Starter Cable May Contact Power Steering Hose

RECALL

Models Affected: 2004 through 2006 Model Year "Vision"

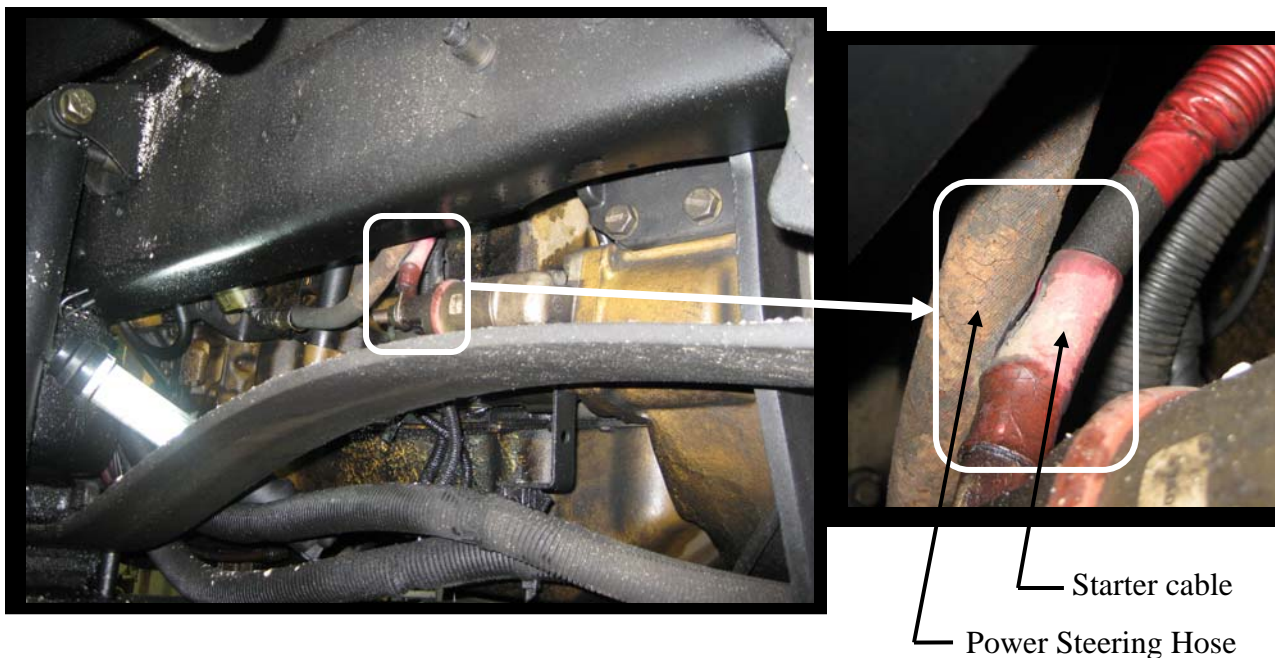
The starter cable may contact and potentially chafe against the steel braided power steering hose thereby creating a direct short which could result in a fire.

1. Park the bus on a level surface, apply parking brake, and remove ignition key and chock wheels.
2. Disconnect Batteries: Note when disconnecting the batteries, remove the Negative cable first.
3. On lower left side (driver's) of engine; inspect the positive starter cable and power steering hose for possible contact as shown below.

Inspect for proper clearance between the starter cable and the power steering hose. If insufficient clearance is found, install a clamp to prevent further contact. Any damaged power steering hoses or starter cables must be replaced.

Install dual swivel saddle mount and cable ties.

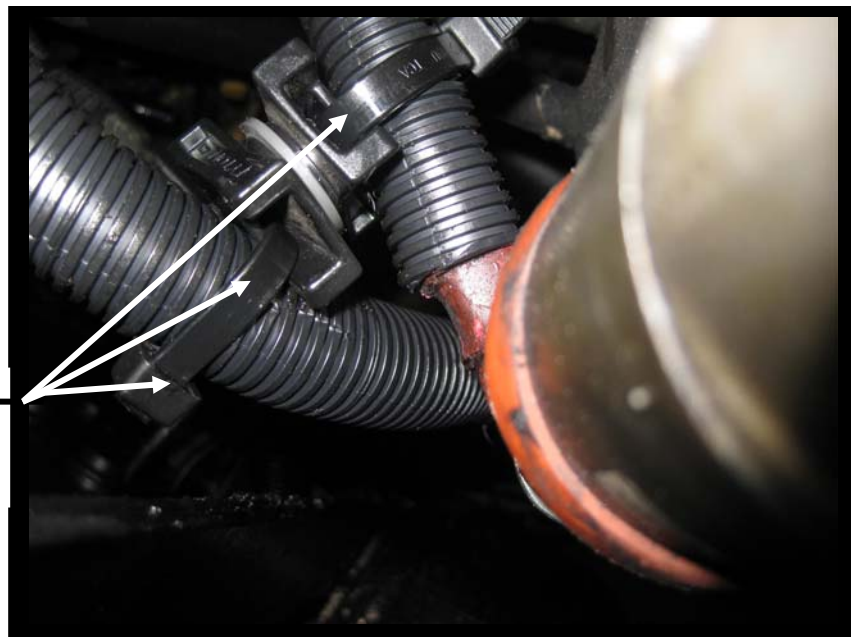
4. If the starter cable has contacted the power steering hose, separate and inspect both for any possible damage. If either has been damaged, contact Blue Bird Recall Administrator for a replacement.
5. If there is no contact and a minimum of one (1) inch clearance between the starter cable and power steering hose, no further action is required.
6. If there less than one (1) inch clearance, install a dual swivel saddle mount and two cables ties between the power steering hose and starter cable and secure with two cable ties.
